JLRTB02052NAS3
TECHNICAL BULLETIN
07 AUG 2023

501-03

Rear Doors Difficult To Open

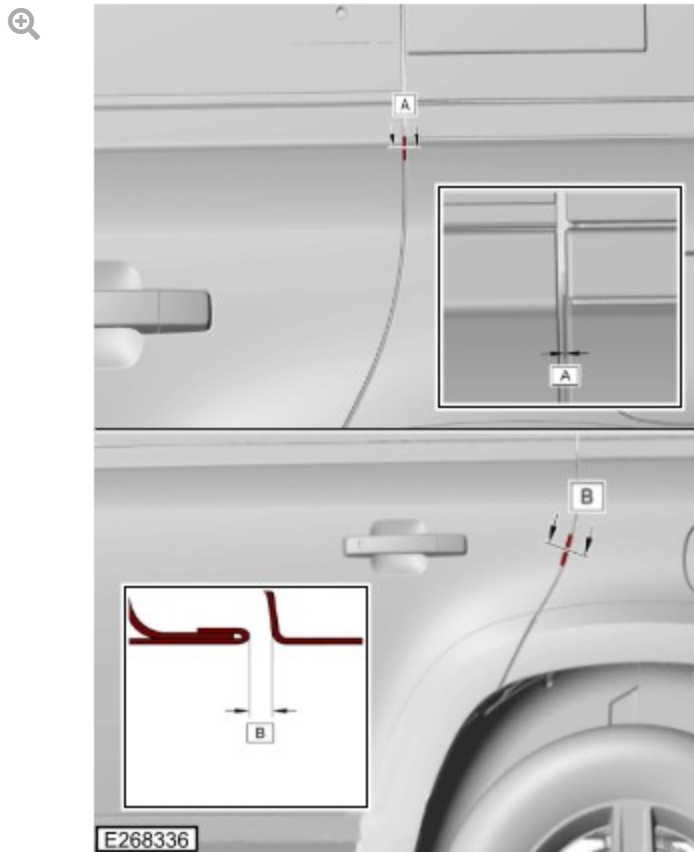
Check the alignment of the rear door(s) in the areas shown in the illustration.

SECTION	DESCRIPTION	GAP	PROFILE
A	Rear door to rear quarter	N/A	0.0 ± 0.5 mm
B	Rear door to rear quarter	3.5 ± 0.7 mm	0.0 ± 0.7 mm

Only adjust the rear doors that are either out of alignment tolerance or do not have a gap of 2.8 mm.

Adjust the rear door(s) to be as far rearward as possible while still being within tolerance, the gap must be 2.8 mm (see TOPIx Workshop Manual section 501-26: Body Repairs: Vehicle Specific Information and Tolerance Checks - General Procedures - Rear Door Alignment).

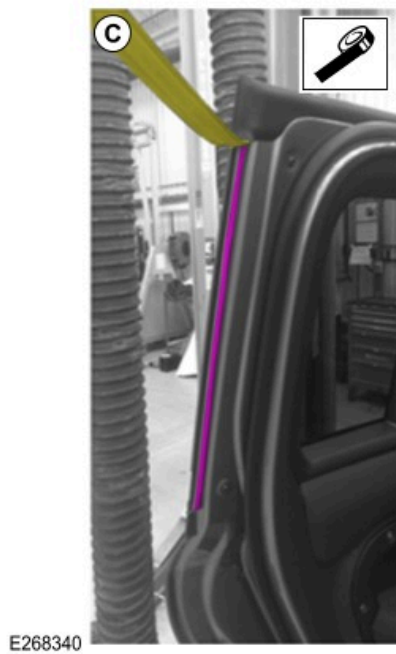
(A) Reposition the section of rear door seal shown in the illustration.

(B) Make sure the area highlighted in the illustration is clean, dry and free from contamination.

(C) Apply the double sided adhesive tape along the seal path on the door frame, as shown in illustration 'C'. Do not remove the protective backing from the double sided adhesive tape at this stage.

(D) Install the section of rear door seal removed during step 2.

E268351

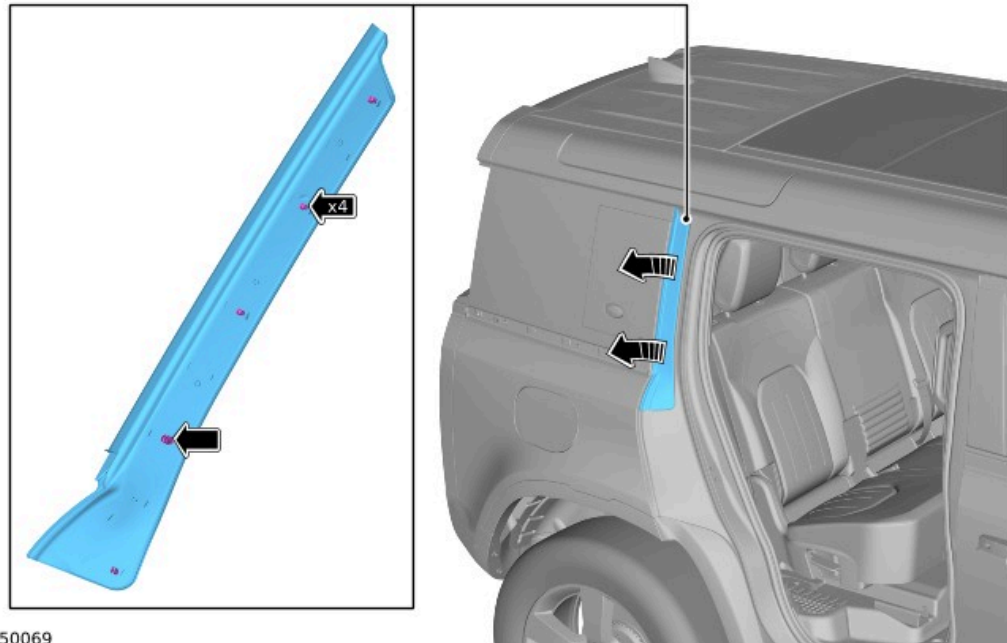
(E) With the rear door seal installed, remove the protective backing from the double sided adhesive tape.

(F) Apply firm pressure to the rear door seal to make sure it is adhered to the double sided adhesive tape.
